MODIFICATION REPORT

Access Logistics Park

884-928 Mamre Road, Kemps Creek
Lots 52 & 53, DP259135

SSD-17647189-Mod-3

Figure 4. Stage 2 Estate Master Plan / Benching Plan (Source: Nettletontribe Architects, 2026)

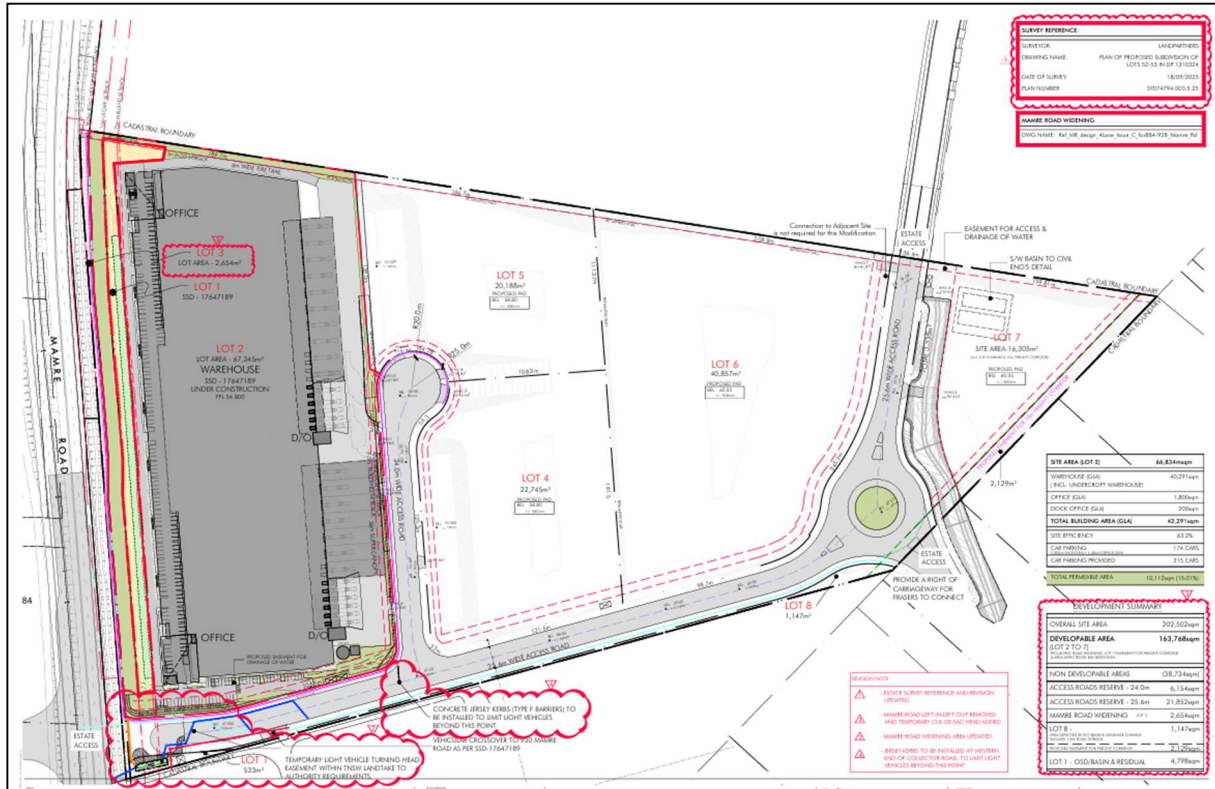
The proposed modifications involve the deletion of the LILO intersection road together with signage and traffic restrictions as denoted by Penrith City Council (refer to **Figure 4** and the Site Masterplans at **Appendix C2**).

Figure 5. Landscape Masterplan (Source: Geoscapes, 2026)

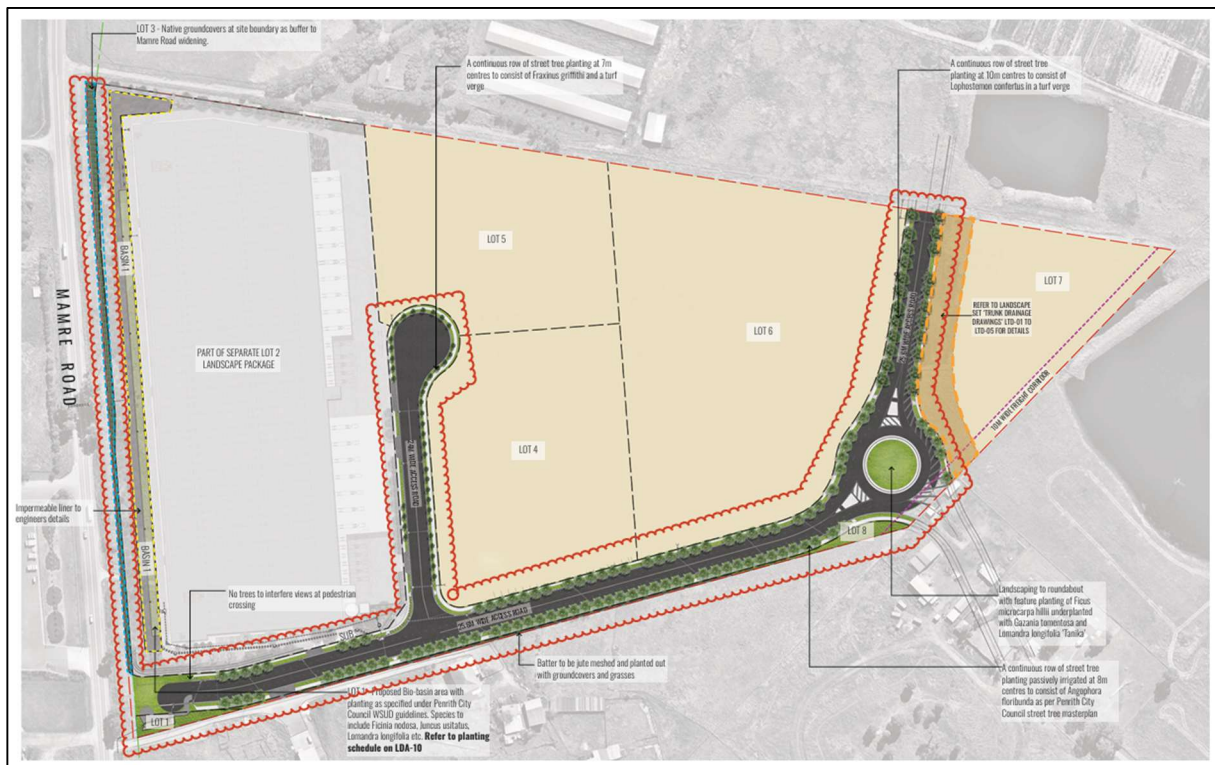
The modified proposal involves amendments to the approved landscaping interfacing with the road layout. **Figure 5** illustrates an excerpt from the Landscape Plans. Refer to the Landscape Estate Masterplan at **Appendix C3**, the Landscape Plans provided at **Appendix C4**, the Landscape Design Report at **Appendix C5** and the Landscape Letter at **Appendix C9** for further details.

- Trees previously proposed along Lot 3 have been removed due to the presence of a high-voltage (HV) power line running along the extent of this area. In lieu of trees, low-level grasses and groundcover planting are still proposed to maintain landscape treatment while complying with safety and clearance requirements;

- The entire tree schedule across the Site has been updated to align with Penrith City Council’s Draft Street Tree Master Plan, ensuring consistency with Council’s current strategic planting objectives;

- The location and spacing of trees have been amended to comply with Penrith City Council’s recommended planting distances and to respond to the Sightline Assessment prepared by MU Group, ensuring appropriate visibility and safety outcomes are achieved; and

- Trees have been removed beyond the defined construction boundary due to a lack of control over these areas. These areas fall under the authority of TfNSW. Turf has been proposed within these zones to avoid the risk of sacrificial planting works occurring in areas outside the project’s control.
